# CITY OF SMYRNA COMMUNITY DEVELOPMENT DEPARTMENT MEMORANDUM

**RE: ANNEXATION AND REZONING CASE Z17-014 – 2800 & 2810 Spring Road**

Development of a mixed use development consisting of a hotel, office building, retail building and an apartment building.

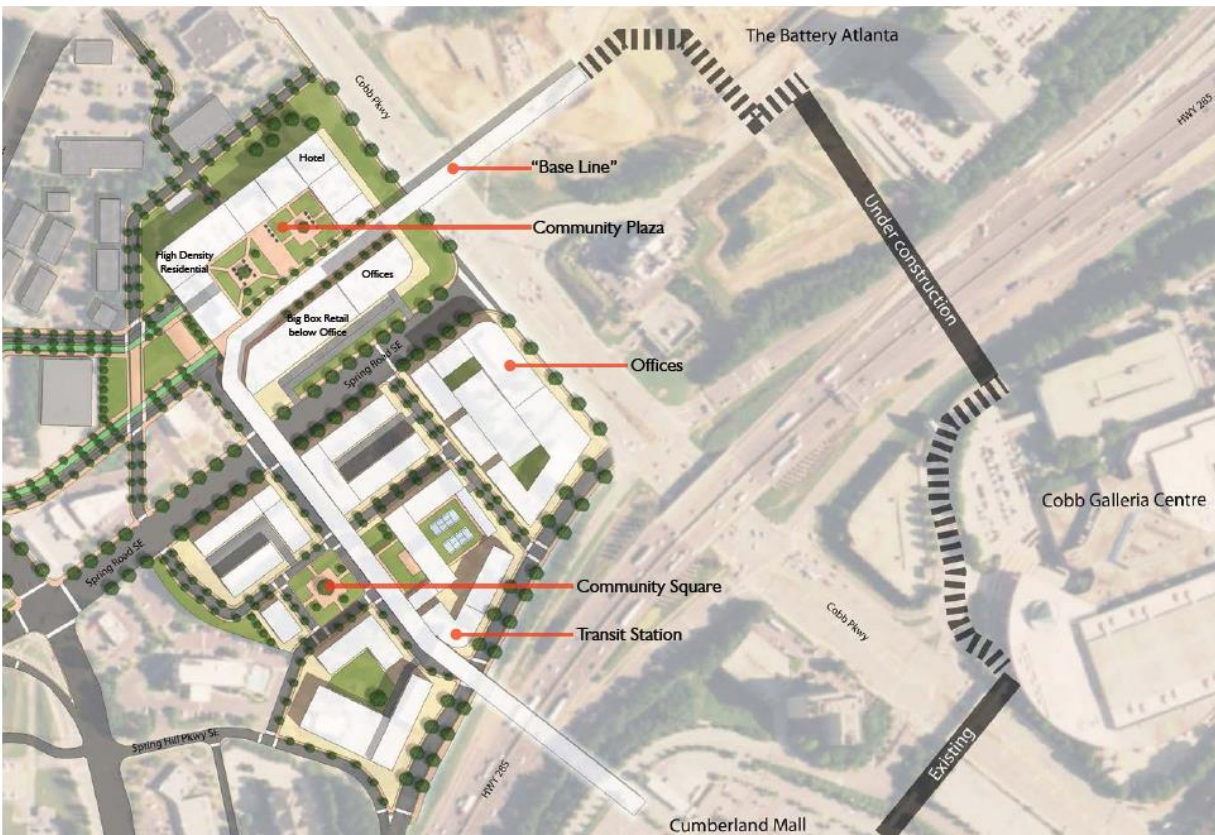
The City's Fire Marshal's Office has reviewed the proposed plan and believes that in the current design they cannot adequately serve this development. The Fire Marshal's Office has provide the following items that need to be addressed with respect to the site plan to provide appropriate emergency response and access:

1. All entrances must be a minimum 26' in width from back of curb to back of curb (BOC);
2. All private roads through the development must be increased to 26' width (BOC);
3. All private roads shall be constructed to city standards;
4. All radii within the development shall be a minimum of 25';
5. The emergency lane around the multi-family building shall be paved;
6. The drive aisle around the retail building shall be a minimum of 20';
7. A 26' paved access lane shall be provided around the office building;
8. The perpendicular parking between the hotel and retail building on main access road presents accessibility issues;
9. The five parking space near the first right-in/right-out entrance shall be removed; and
10. There is no parking or accessibility design for the office building.

This development will need to address all the issues described above and meet all the city requirements with regards to the fire code.
